TO : All Bidders
FROM : Mark Graham
PROJECT : Rio Vista Elementary School Modernization
Project 1719800.41
SUBJECT : Addendum 1
DSA : 04-118156 / File 36-55

1. ADD ALTERNATES

ADD-01
SK6

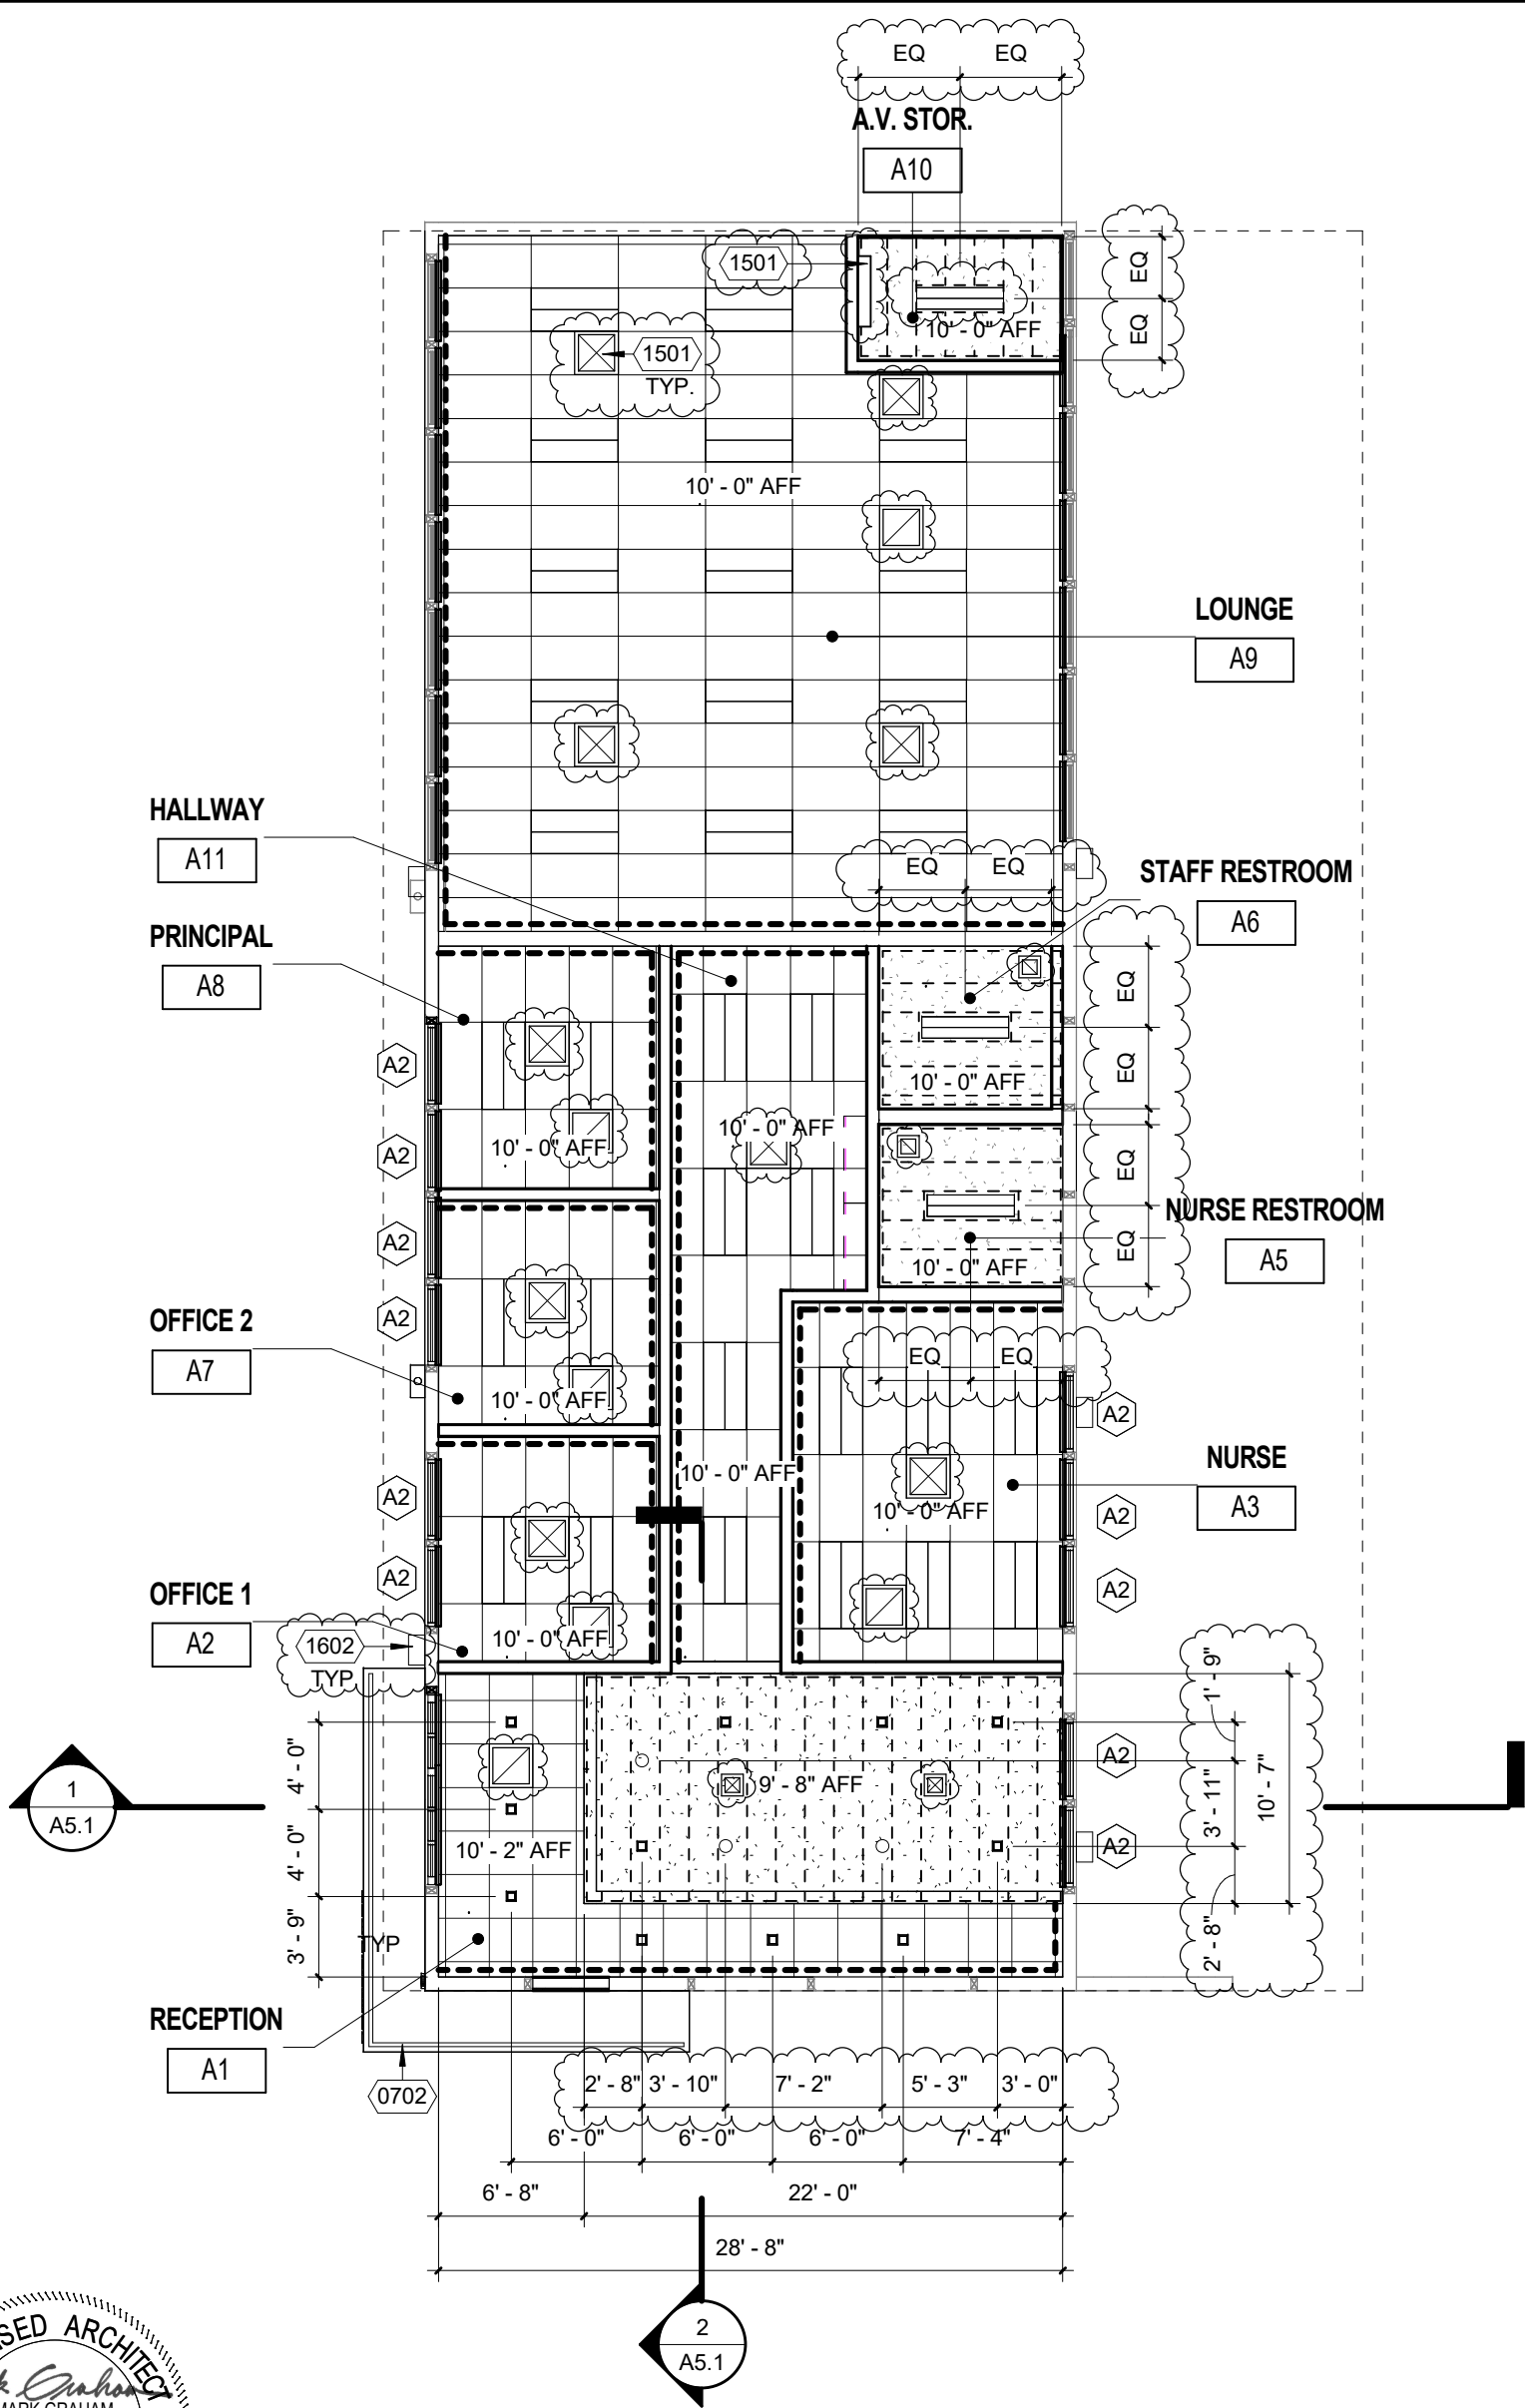
A. Detail 2

1. Replace detail with the attached SK6.

DRWN:	CL	ADD-01 SK7
CHKD:	SJ	
DATE:	10/27/19	
SCALE:	1/8" = 1'-0"	
JOB NO:	1719800

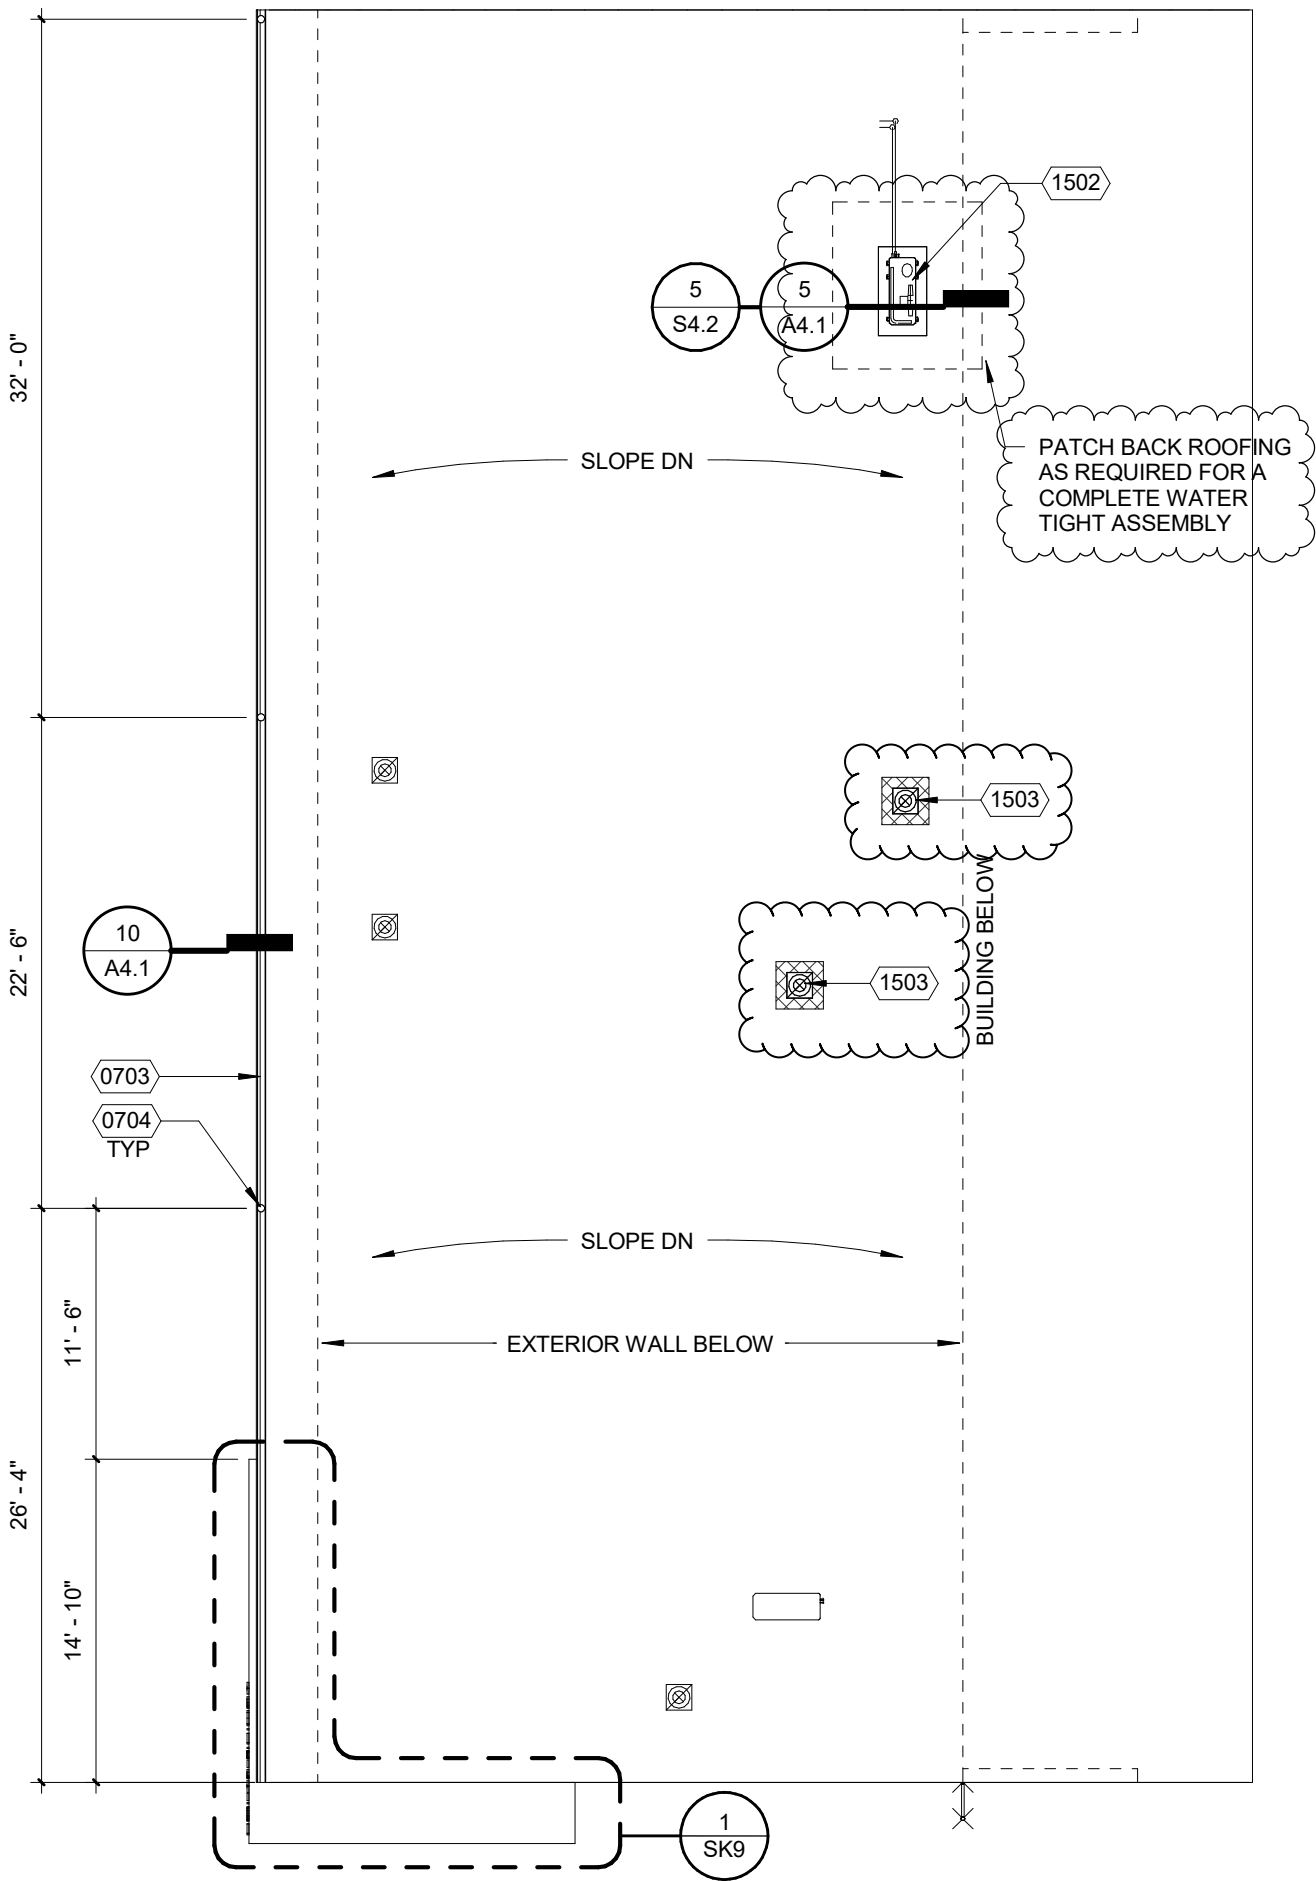
B. Detail 2

1. Replace detail with the attached SK7.

SK9

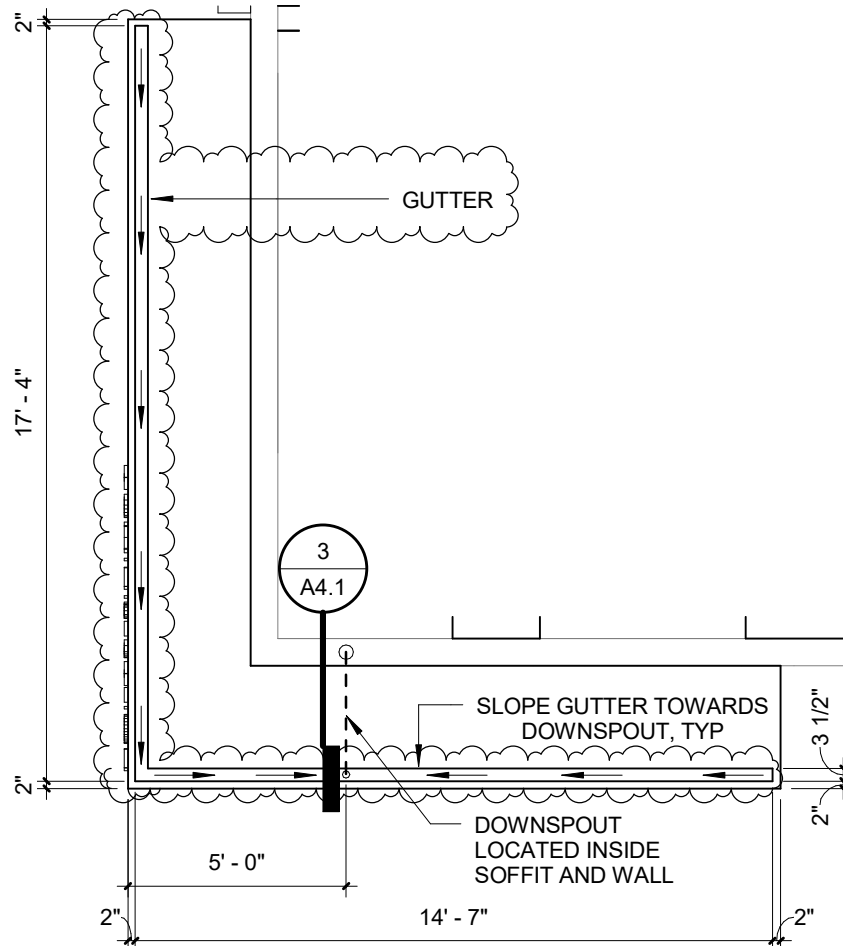
D. Detail 6

1. Replace detail with the attached SK9.

SK10

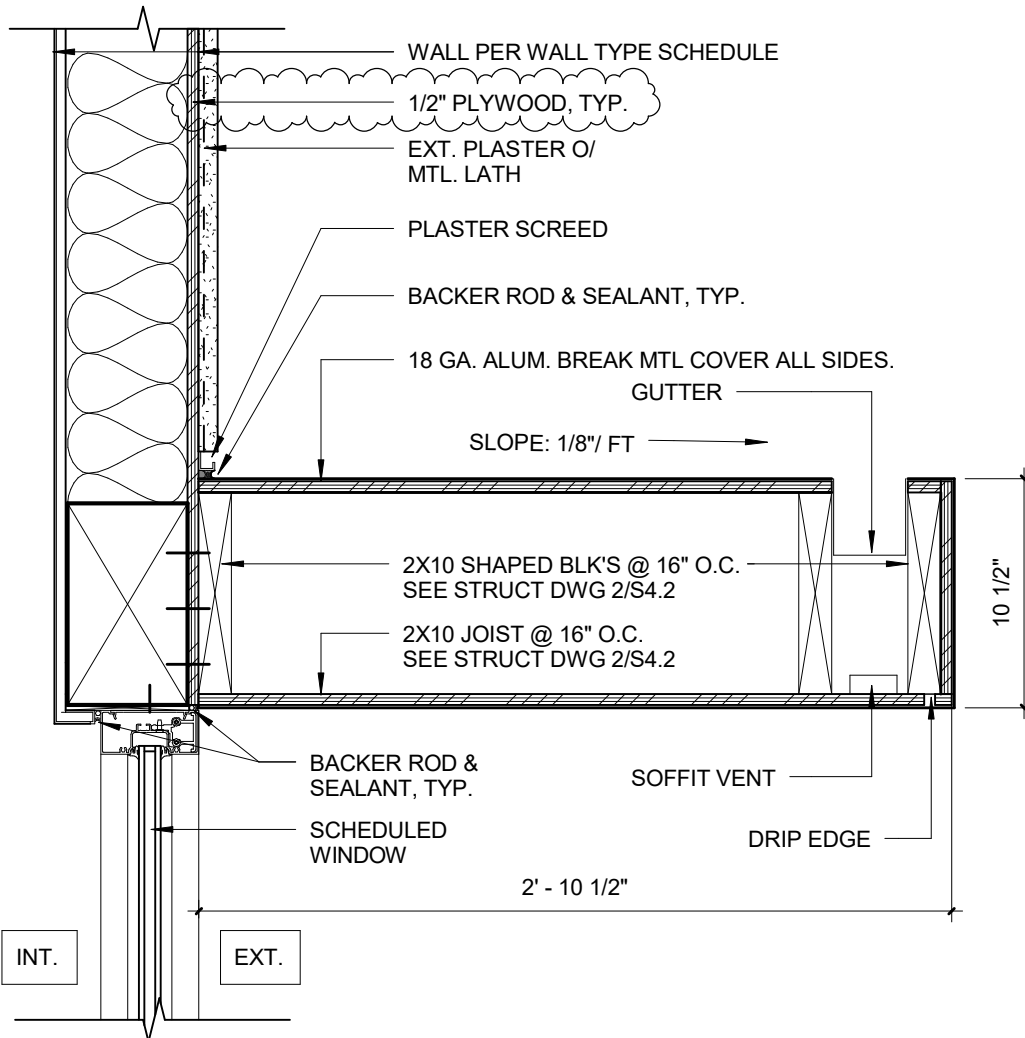
E. Detail 7

1. Replace detail with the attached SK10.

SK13

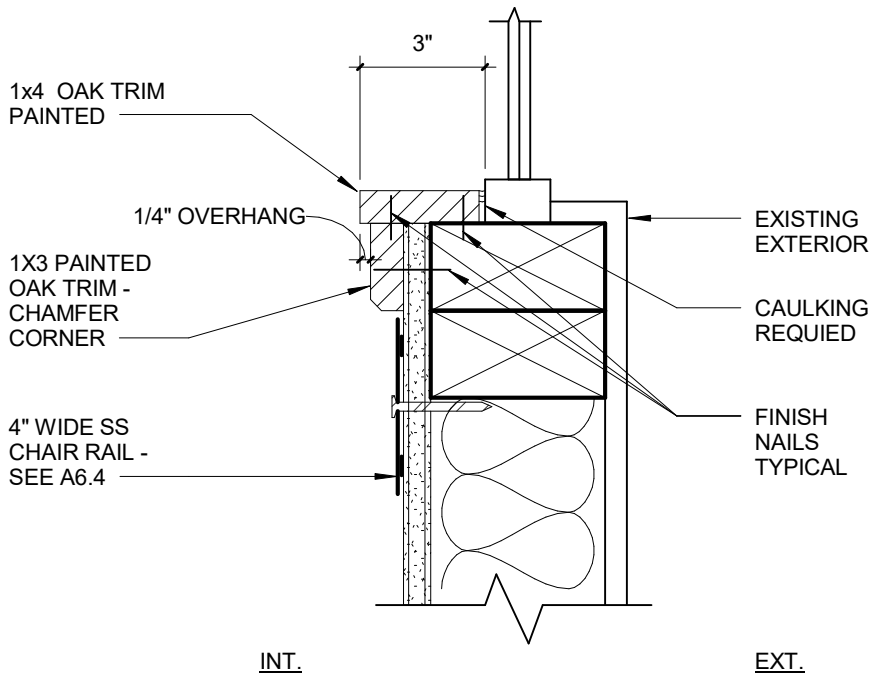
B. Detail 5

1. Add wall section detail per the attached SK13.

WALL INFILL		ADD-01 SK14
DRWN:	Author	
CHKD:	Checker	
DATE:	11/14/19	
SCALE:	1" = 1'-0"	
JOB NO:	1719800

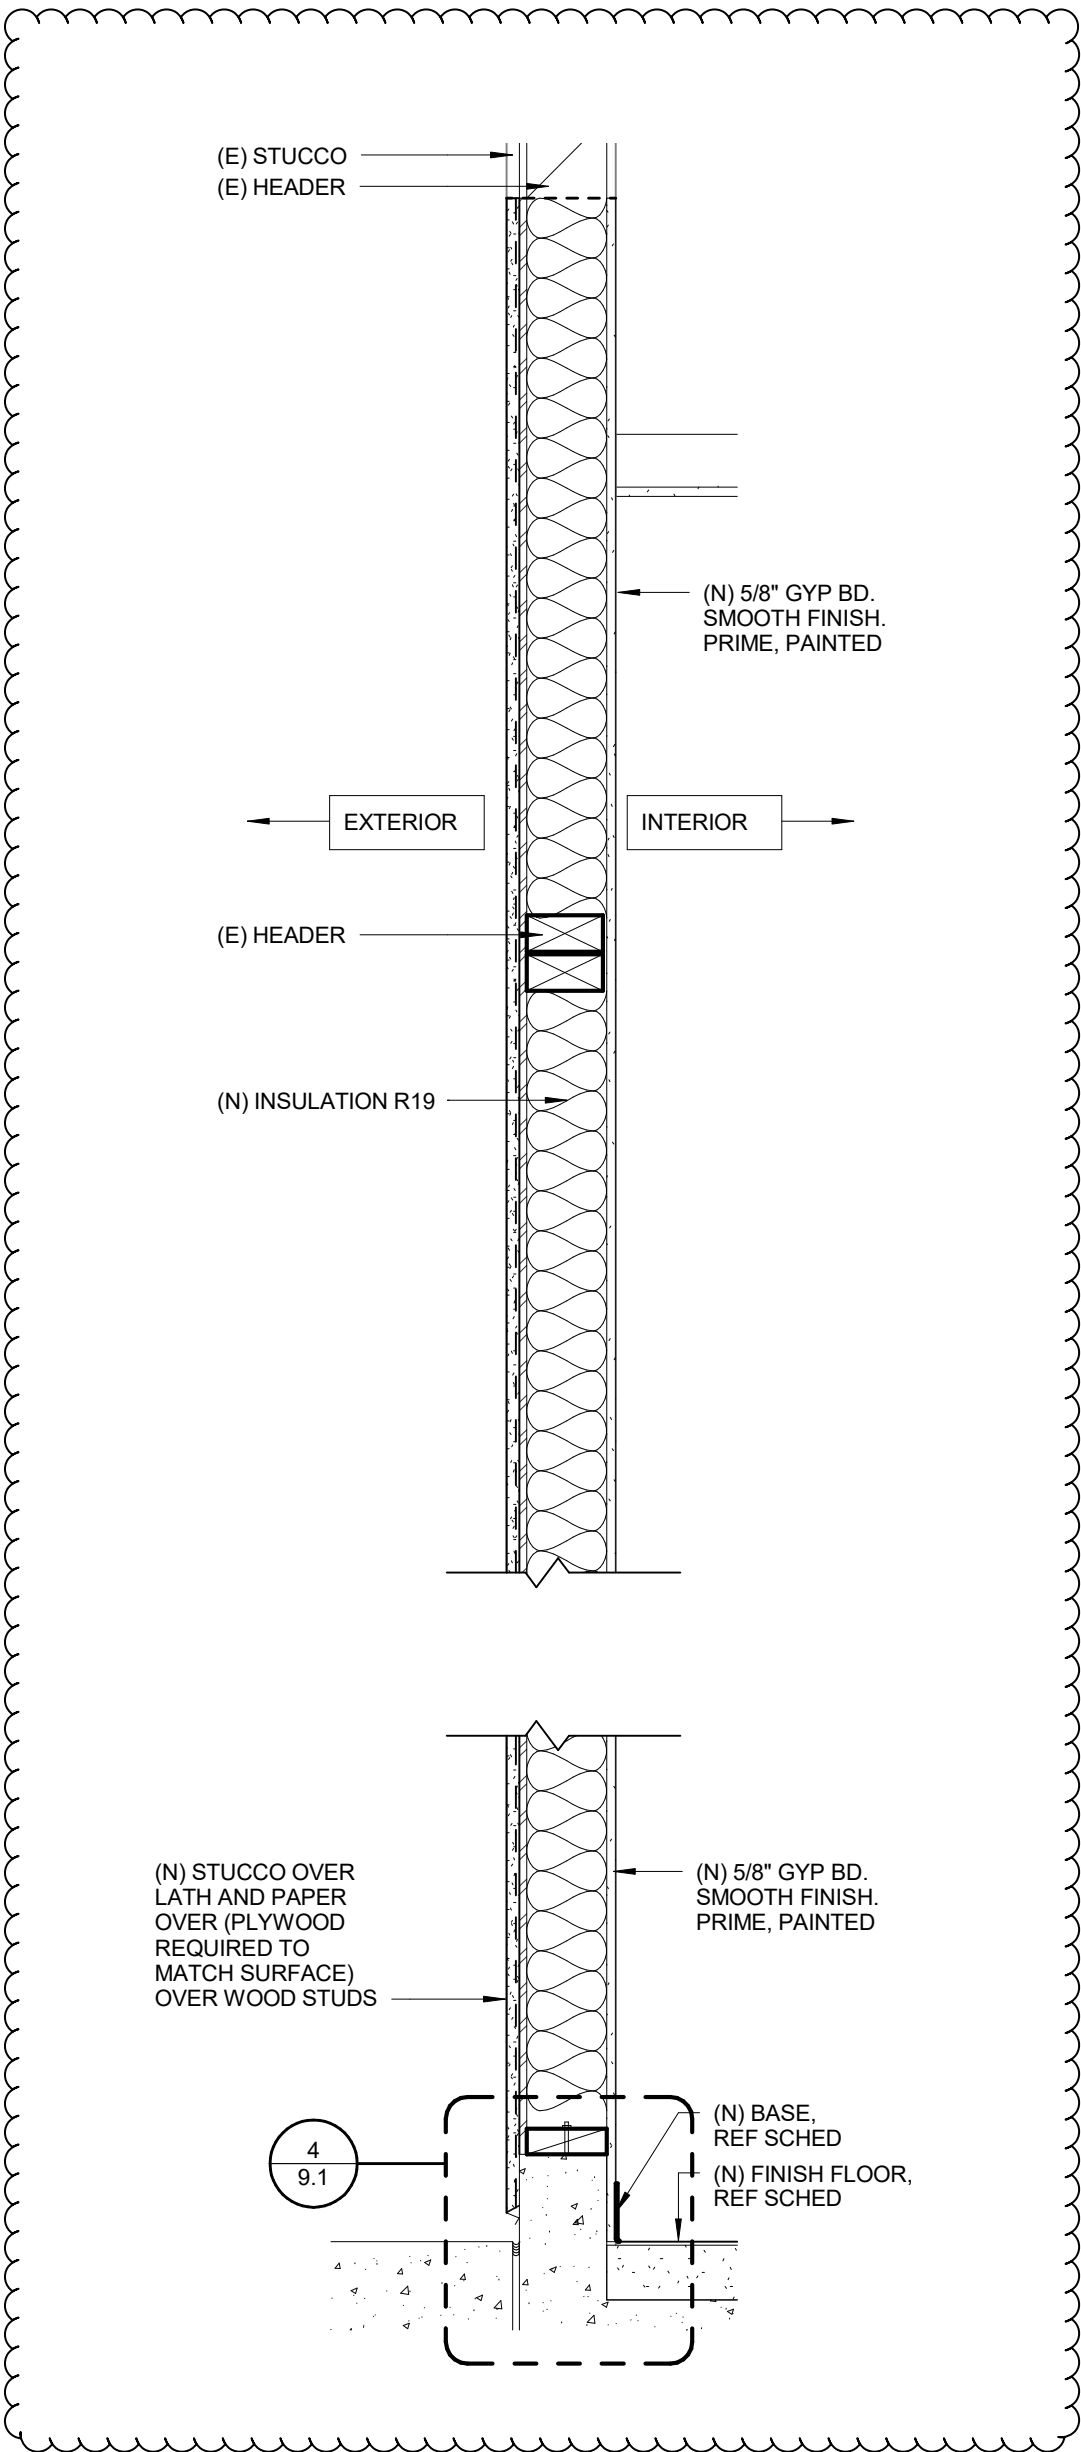
B. Detail 4

1. Add wall section Detail 1 per the attached SK14.
